HMA RESURFACING
 NHSX-092-8(43)--3H-54

PLANS OF PROPOSED IMPROVEMENT ON THE
PRIMARY ROAD SYSTEM
KEOKUK COUNTY
HMA RESURFACING
 E of IA 21 to 200th St

D2 Questions for District 5 – **with Responses in GREEN Text:**

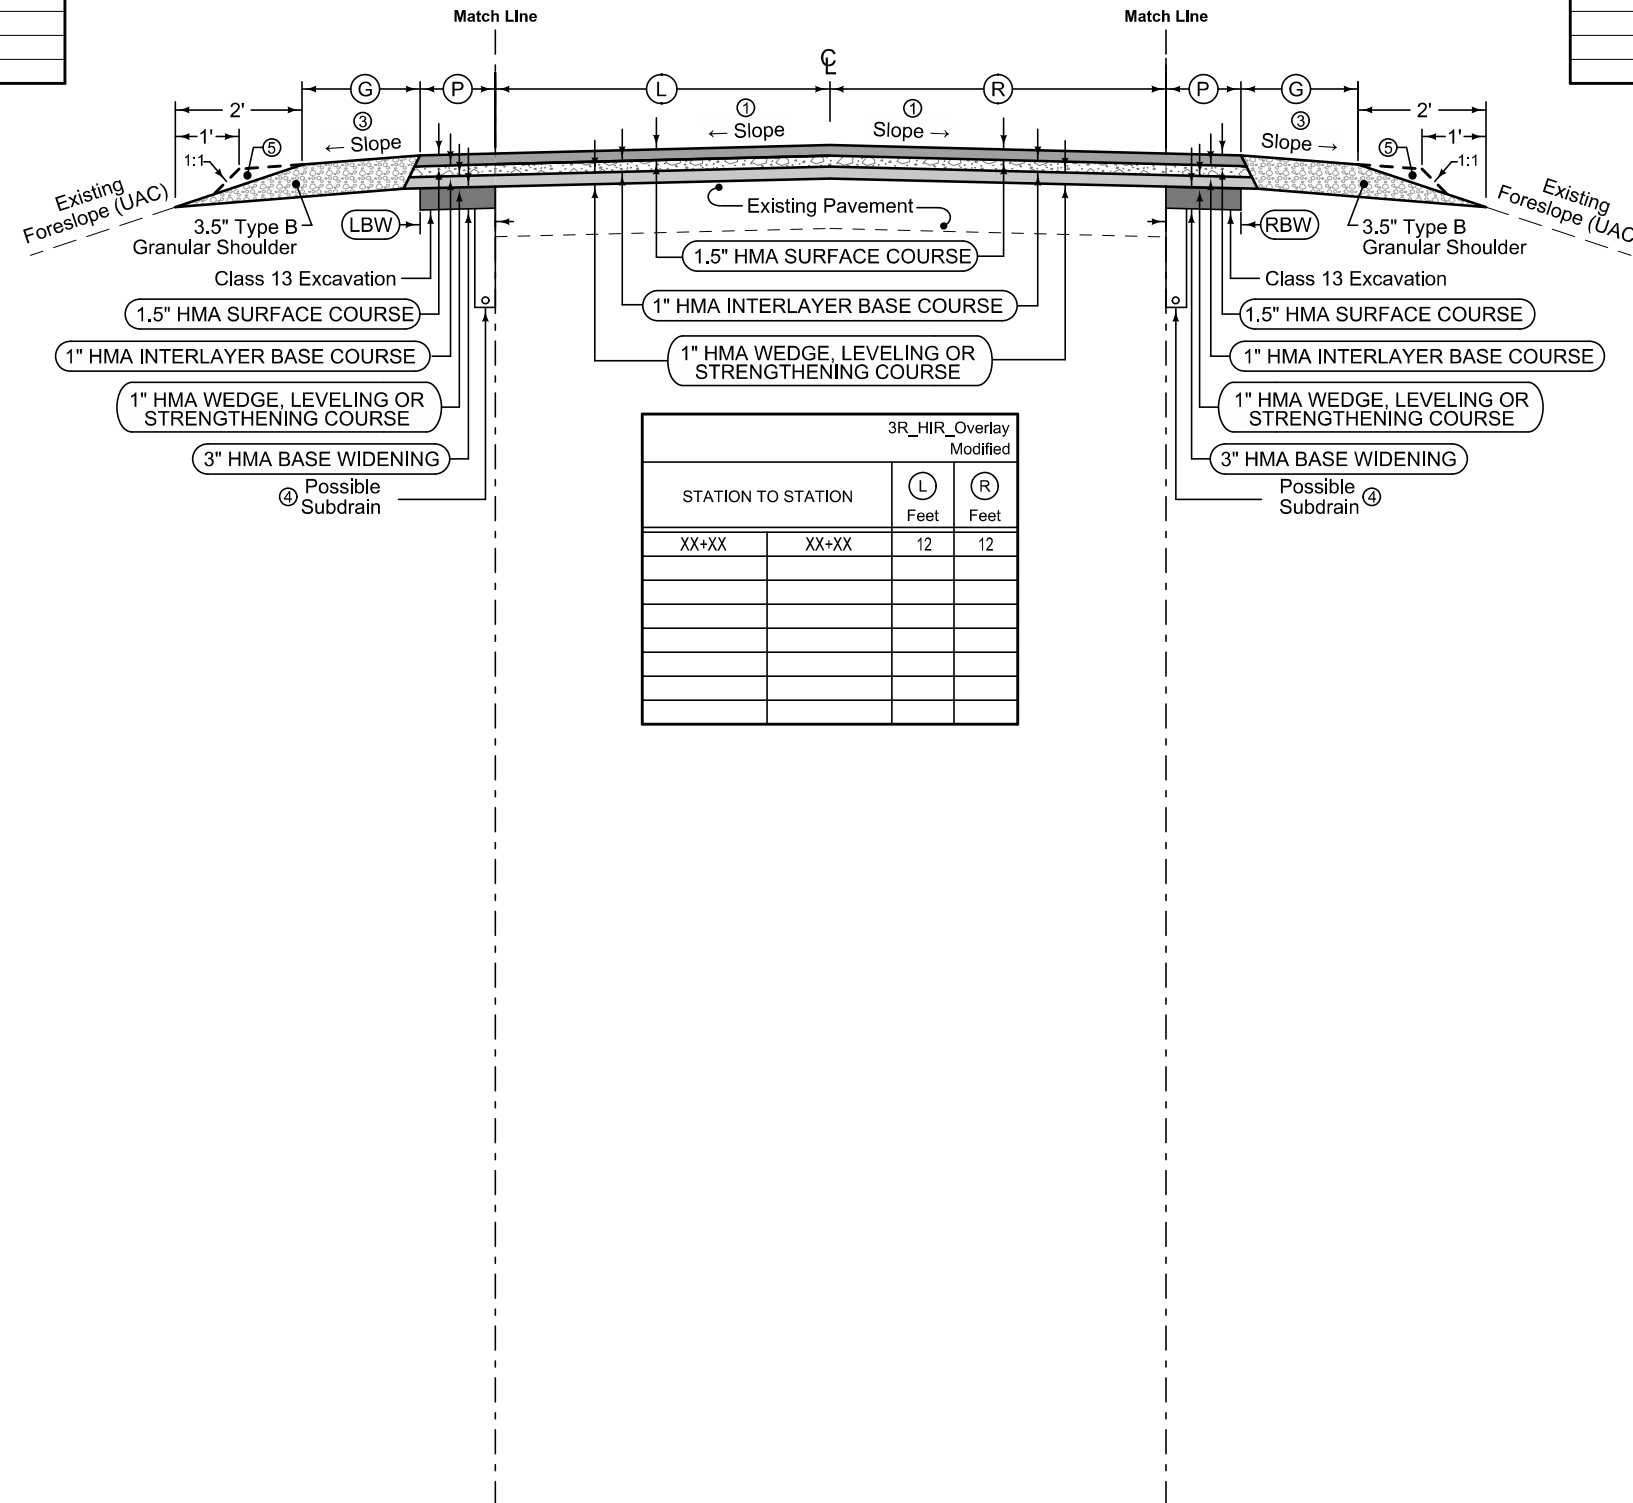
- a. Page 10 of the Project Concept has the following for Treatment; "Similar to what was constructed in 2021 as part of project NHSX-092-8(40)—3H-54, PIN 20-54-092-010. A functional 3 lift HMA overlay, including a 1" HMA interlayer has shown to be effective in reducing reflective transverse PCC joint cracking into the HMA surface course. Construct 1" Strengthening / leveling (scratch) course to avoid interlayer delamination if interlayer was place directly onto PCC, 1" HMA Interlayer, 1.5" surface (total 3.5" HMA)". Please verify the pavement composition on the Typical Section.

- a. Page 10 of the Project Concept has the following for composition for the proposed 4' Paved Shoulder "4 ft. HMA paved shoulders with 3" min. HMA base widening". Please verify the pavement composition on the Typical Section.

- a. Page 10 of the Project Concept has the following for composition for the remaining 6' Granular Shoulder; "3.5" thick x 6 ft. wide granular surfacing." Please verify the pavement composition on the Typical Section.

- i. **2022-05-02 Field Exam Response: Revise the Typical Section to the following: 4" HMA Base Widening + 2" HMA Intermediate Course + 1.5" HMA Surface Course. Increasing the thickness of the Base Widening Course from 3" to 4" will improve the shoulder's durability during construction, especially since the 1" Strengthening Course has been removed (Strengthening Course is generally added to the base widening course before construction traffic is moved onto the shoulder, thus giving the shoulder an effective thickness of 4" during the first stage of construction traffic). Replacing the 1" Strengthening/Leveling (Scratch) Course + 1" Interlayer with a single 2" Intermediate Course will eliminate a resurfacing pass and a coat of paint, which should lead to a cost savings. Furthermore; the consistency, workability, and durability of 1" HMA Surface Courses (and HMA Strengthening Course) has been observed to be inadequate (1.5" should be considered the minimum thickness of a single HMA Surface Course, even for High Performance Thin Lift Surface Courses), the main issue is the 3/4" nominal aggregate size is too close to the 1" thickness. Also, the effectiveness of Interlayer to reduce reflective cracking from the underlying PCC appears to be doubtful and may not be worth the premium cost of Interlayer, therefore more projects will likely replace Interlayer with Intermediate Course in the future. FYI, 1" thickness for Interlayer is generally OK for use when it's specified.**

- i. **2022-05-02 Field Exam Response: Specify a minimum 2% cross-slope and maximum 3% cross-slope. There should be some slope-correction flexibility in the 2" Intermediate Course to adjust the resurfacing slope to satisfy these slope requirements.**

- i. 2022-05-02 Field Exam Response: Revise the Typical Section to the following: 4" HMA Base Widening + 2" HMA Intermediate Course + 1.5" HMA Surface Course. Increasing the thickness of the Base Widening Course from 3" to 4" will improve the shoulder's durability during construction. The District 5 Team recommended that the shoulder composition and widths be coordinated with the Intersection Improvement Project NHSN-092-8(36)--2R-54.

- i. 2022-05-02 Field Exam Response: Confirmed. Specify 3.5" thick x 6' wide granular shoulder material.
- b. Shall we assume Granular Shoulder is 1" below existing edge of pavement due to washout?
